ENVIRONMENTAL REVIEW TEAM REPORT

FAWN RIDGE ESTATES
HARWINTON, CONNECTICUT

JANUARY 1980

SIMPLIFIED SITE PLAN *

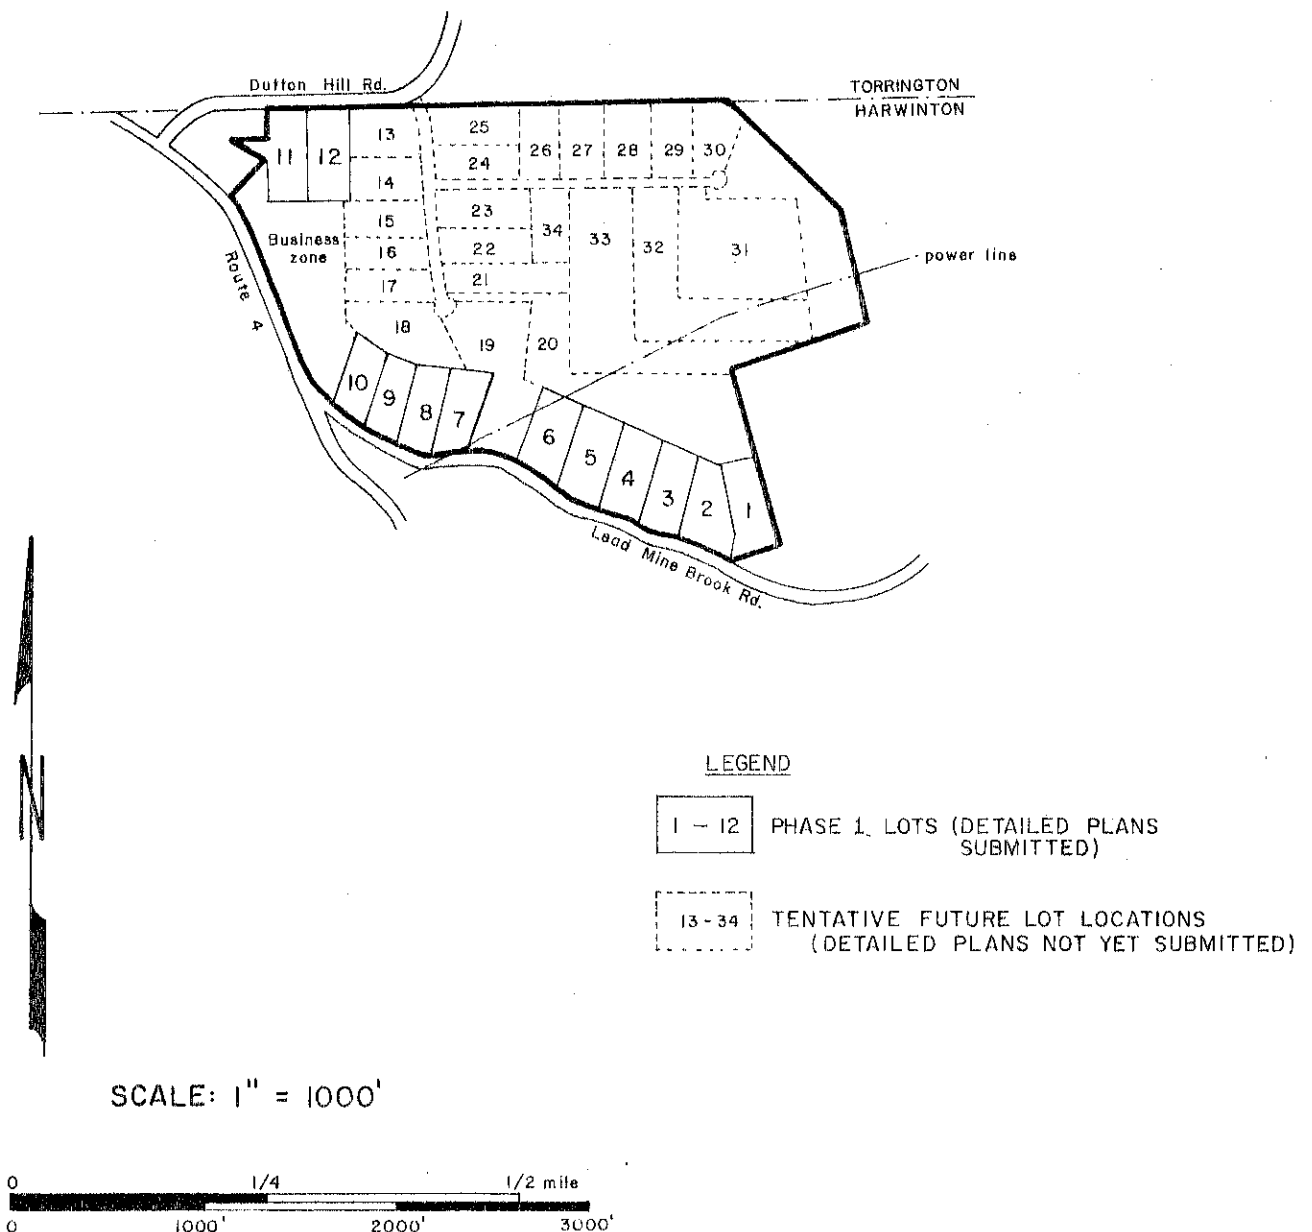
- . Due to steep slope conditions, it is not believed that the straight thru driveways proposed for lots 1-10 reflect what will eventually be installed on the property. It is much more likely that such drives will cross the lots diagonally in an S-shaped curve, necessitating some cutting and filling. Such construction could limit the area for sewage disposal. As a result, it is recommended that septic systems and reserve areas be laid out in the preliminary plans with driveways which reflect this pattern.

On lots 1-10, a detailed topography survey could reveal less sloping areas for homesites. The present "Business zone" (see Figure 1) contains several potential homesites with fewer slope limitations than some of the lots 1-10. Eliminating the "business zone", widening lot widths, and siting homes/septic systems in less sloping areas would also provide opportunity to put driveways in on more gradual grades with less land disturbance. This is an alternative which should be considered.

FIGURE 3.
DESIGN POINTS & DRAINAGE AREAS
FOR PEAK FLOW CALCULATIONS

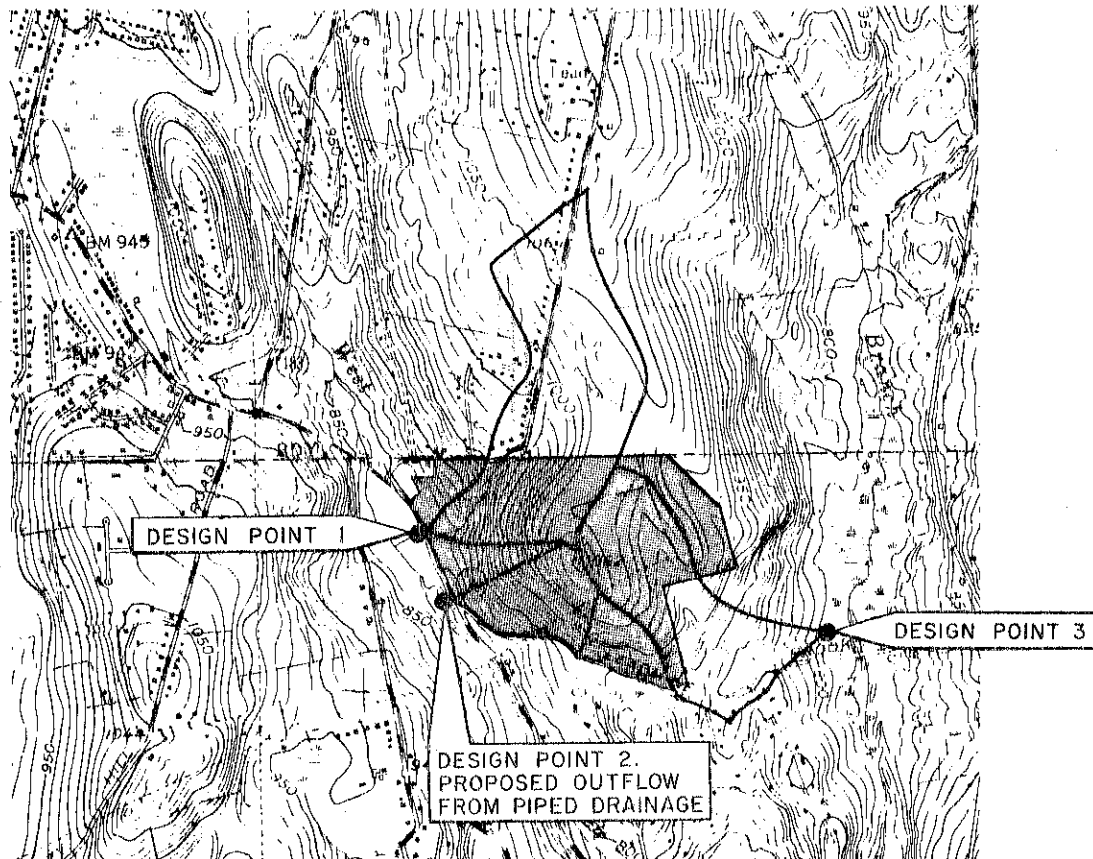
A calculation was made of peak flows to be expected both before and after development at two points of streamflow near the site. A calculation was also made for a proposed piped-drainage outlet near the intersection of Route 4 and Lead Mine Brook Road. The latter calculation cannot be easily compared against present conditions since a rerouting of drainage flow would be involved. Although a standard hydrologic method was used in the calculations, the results (shown in the following table) should not be interpreted as hard-and-fast data, but rather they should be regarded as guidelines to the potential for hydrologic change from implementation of the proposed project. The sites chosen for peak-flow evaluation and their respective drainage areas are shown in Figure 3.

FIGURE 4.
VEGETATION TYPE MAP

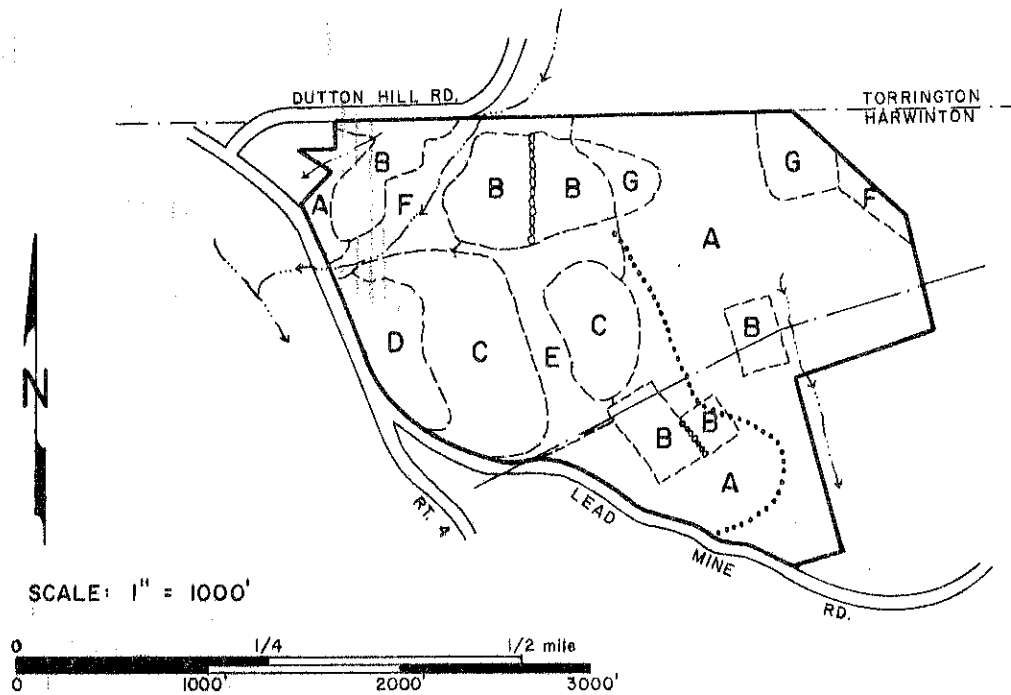
An alternate location to the proposed interior road would be where the present woods road goes upward into the property, off of Lead Mine Brook Road (see Figure 4). Advantages of this alternative are:

1. Less cuts and fills, stream not a factor.
2. Opportunity for storm water management basin for road water runoff.

The trees present in Stand F (streambelt/wetland) are in very poor condition as a result of being over-crowded. A light fuelwood thinning, removing perhaps one fourth of the total number of trees, will improve the condition of this stand over time by reducing competition between trees. This thinning should favor tree species other than red maple, and focus on removing the poorest one-quarter of the trees in the stand. To avoid irreversible soil damage this thinning should be implemented during the winter when the ground is frozen or the summer when the ground is relatively dry. A publicly employed service forester may be contacted to help mark the trees that are to be removed if this thinning is agreed to.

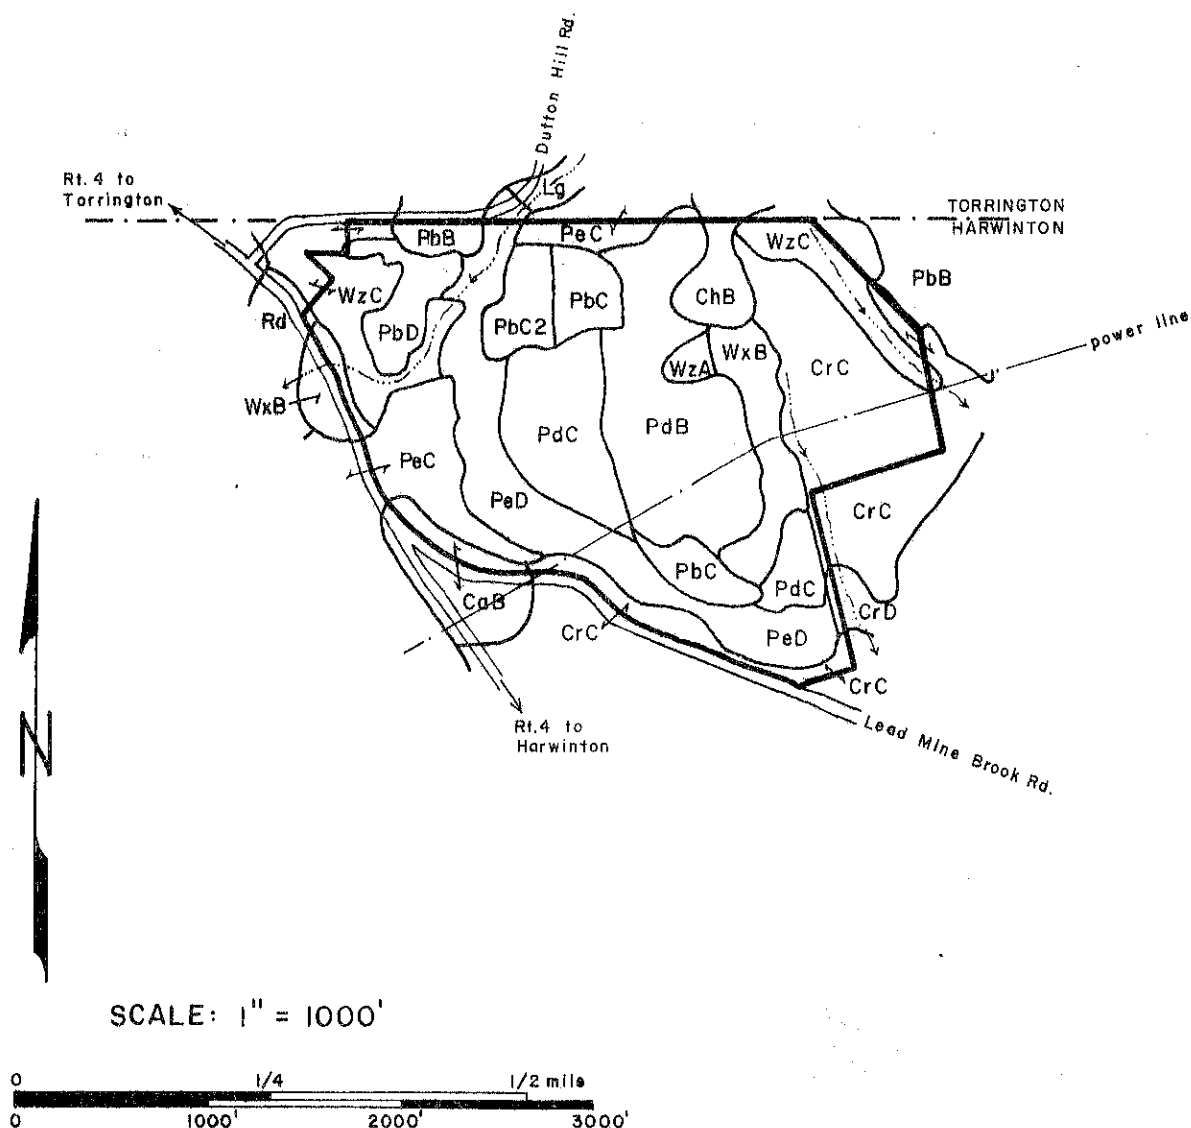
In the description of the First Phase of development, there is concern for adequate driveway sight clearance for the ten units on Lead Mine Brook Road. The removal of shrubs and trees to assist driveway sight clearance for vehicles entering driveways from Lead Mine Brook, and exiting onto Lead Mine Brook Road, is a necessity. In addition, consideration should be given to the possible relocation of the driveways proposed in the plan, especially in areas where the curve of Lead Mine Brook Road may hamper necessary sight clearance. Also, the possible modification to the curve of Lead Mine Brook Road itself should be reviewed as a means to insure adequate driveway sight clearance.

In regard to the Long Range Project Plan, detailed technical plans showing cul de sac size, road width, radius at intersections, etc. are required to adequately evaluate the interior roads shown entering the subdivision from Dutton Hill Road. Possible sight clearance problems exist at the curve of Dutton Hill and Harrison Roads, along with possible drainage problems in the interior of the subdivision and at the gully which runs parallel to Dutton Hill Road on the north side of the subdivision.
